**AGENCY REVIEW**  
DATE: MARCH 18, 2026

**LANDSCAPE PLAN & LEGEND**

E.J. POULTRY  
2401 INTER AVE  
PUYALLUP, WA  
2401 INTER AVE LLC

## 2401 INTER LANDSCAPE REQUIREMENTS

**L1**

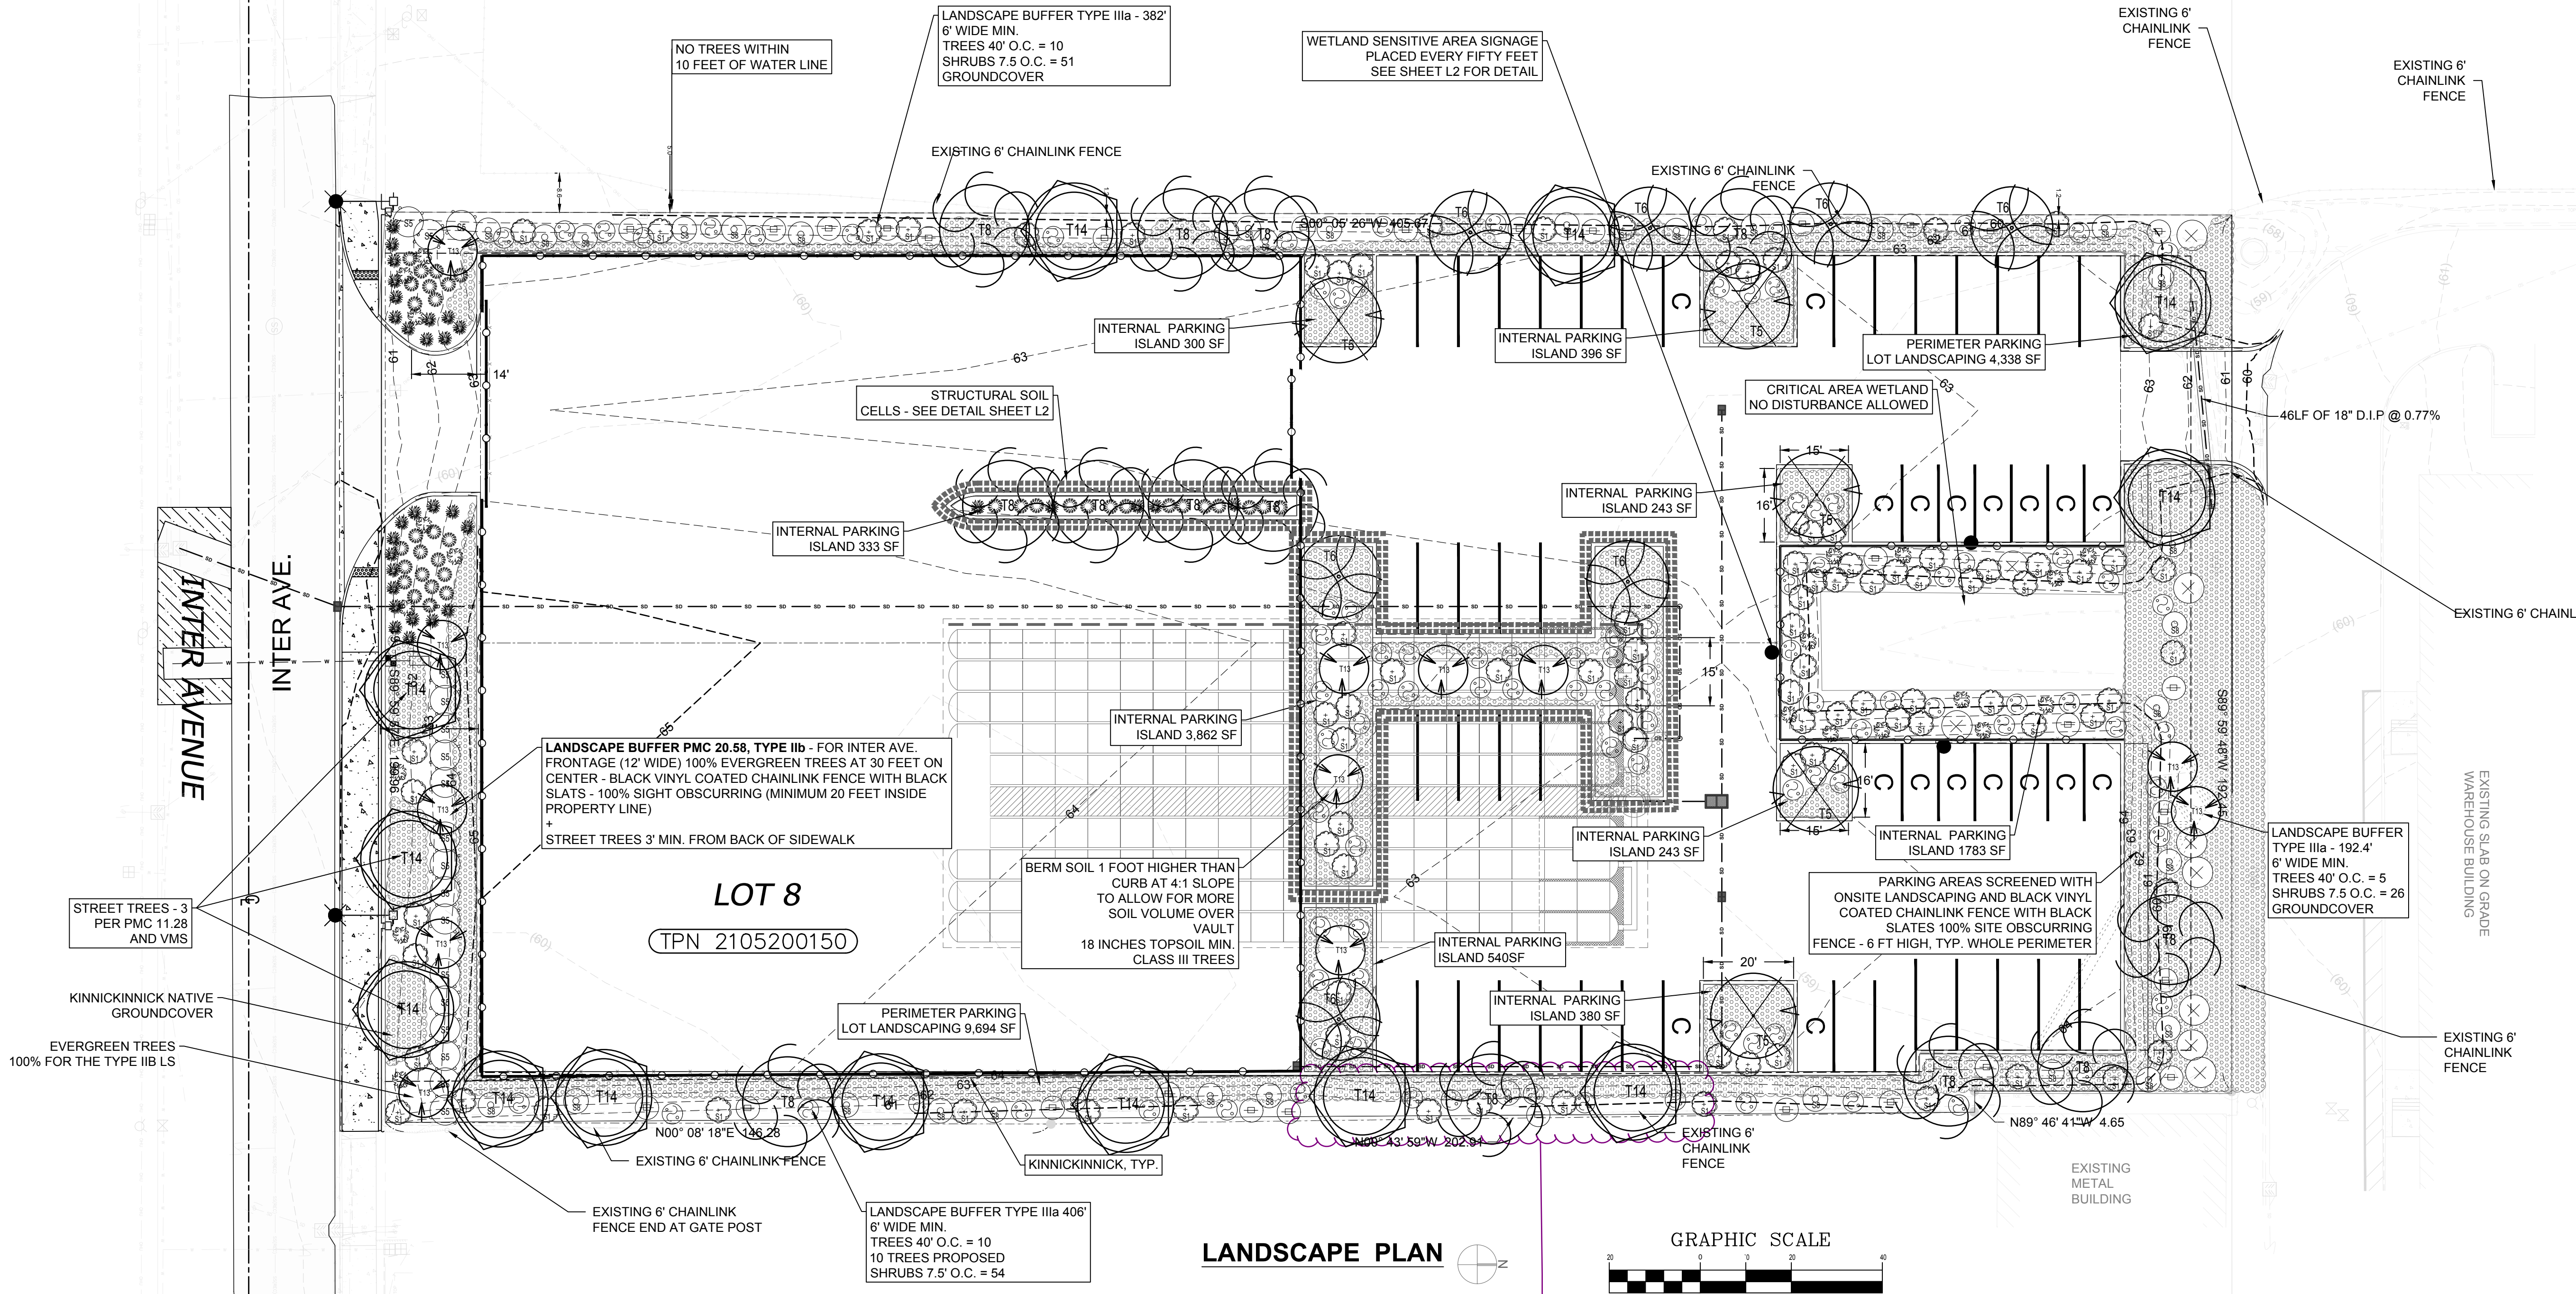
These three (3) trees are located too close to the SD utility line. Minimum spacing from the utility line is 10-feet. These trees should not be planted and instead, more shrubs and plants planted in their place. This will be inspected during the final landscape inspection.
